Technical Memorandum

Subject: Top of Weathered/Sound Bedrock Clarification – West Abutment Drilled Shafts

SN016-1701

Project: Jane Byrne (Circle) Interchange Reconstruction – Cook County, Illinois

BORING LOG 0589-B-01

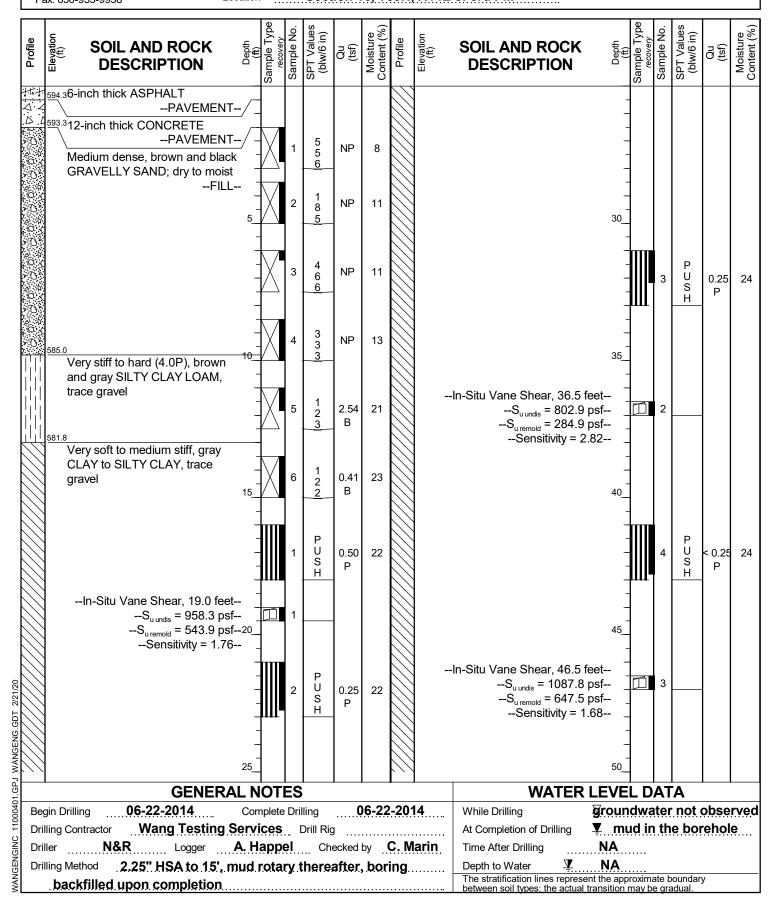
We don't understand why the west abutment has 17' rock sockets while the east has only 6' and the piers have 5'. We think they should revise considering the friction in the so-called weathered bedrock.

Wang drilled Boring 0589-B-01 at the proposed bridge west abutment and encountered refusal 11 feet higher than the other nearby borings.

It is our opinion that the auger refusal reported at an elevation of 501.1 feet elevation in Boring 0589-B-01 is an outlier because bedrock is at as high as about 490.0 feet elevation in this area. We believe this may be due to the presence of a possible boulder/cobble and not weathered bedrock. Since no rock cores were taken at the west abutment where drilled shafts are planned on top of bedrock, this area must be investigated before the planned shaft installation.

The investigation should consist of blind drilling to top of bedrock adjacent to the proposed west abutment foundations and undertake a 20-foot rock core to establish the actual elevation of sound bedrock that is anticipated at about 484 feet elevation. Rock excavation quantities should be considered from 501 feet elevation at the west abutment as per 0589-B-01 but the final quantities should be adjusted according to the actual top of bedrock.

Attached is updated Boring log 0589-B-01. This boring log should be incorporated in the final construction documents.
